IN THE MATTER of applications by Waka Kotahi NZ Transport Agency (Waka Kotahi) to Manawatū-Whanganui Regional Council and Greater Wellington Regional Council for resource consents to enable the construction, operation and maintenance of new state highway, shared use path and associated infrastructure, between Taylors Road (to the north of Ōtaki) and Stage Highway 1 north of Levin.

**SECTION 87F REPORT OF JONATHAN WILLIAMSON –
HYDROGEOLOGY AND GROUNDWATER**

**MANAWATŪ-WHANGANUI REGIONAL COUNCIL AND GREATER
WELLINGTON REGIONAL COUNCIL**

28 April 2023

■ **Figure 1. Example of road alignment cutting through groundwater table.**

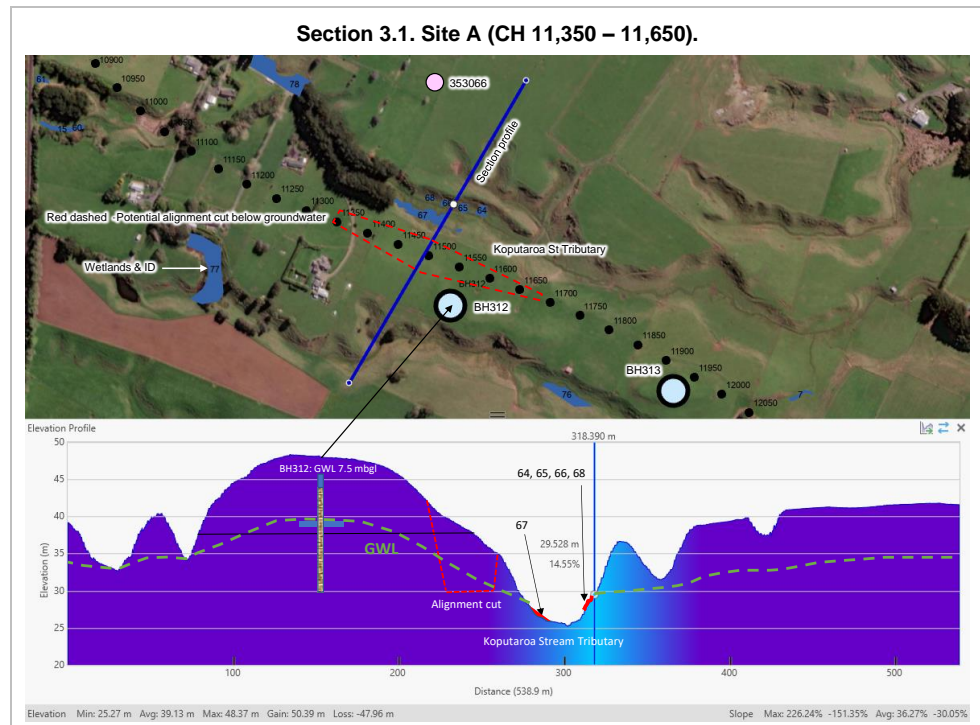
31. Early versions of Dr McConchie's technical assessment and the Stantec (2022a) report indicated that the vertical alignment of the road would intersect groundwater adjacent to wetlands at six locations, as summarised in Table 3. One such location, using Site A as an example, is provided in Figure 1.

32. I am concerned that the quantification on the reduction in hillslope seepage rate in comparison to the natural flow to the wetland was not provided in Dr McConchie’s technical assessment or the Stantec (2022a) report. Therefore, in my view, critical information required for an ecologist to make an assessment on the ecological effects to the wetland of reduced seepage is not available.

36. I took this to mean that the latest road alignment (as per the Consent Application Design) has no excavations. If this is the case, then I am satisfied that there will be no groundwater dewatering effects. I suggest a condition is imposed ensuring no excavations below the groundwater table occur, given its avoidance of effects. However, if excavation is to still occur in the locations identified in Table 3 or in other locations, monitoring of the cut areas and associated wetlands will be required. The draft conditions of consent relevant to groundwater (RGW1 to RGW3) should address excavation below the groundwater table, subject to my view that the Council certification process is the appropriate mechanism for ensuring the appropriateness of the monitoring locations in relation to these cut areas.
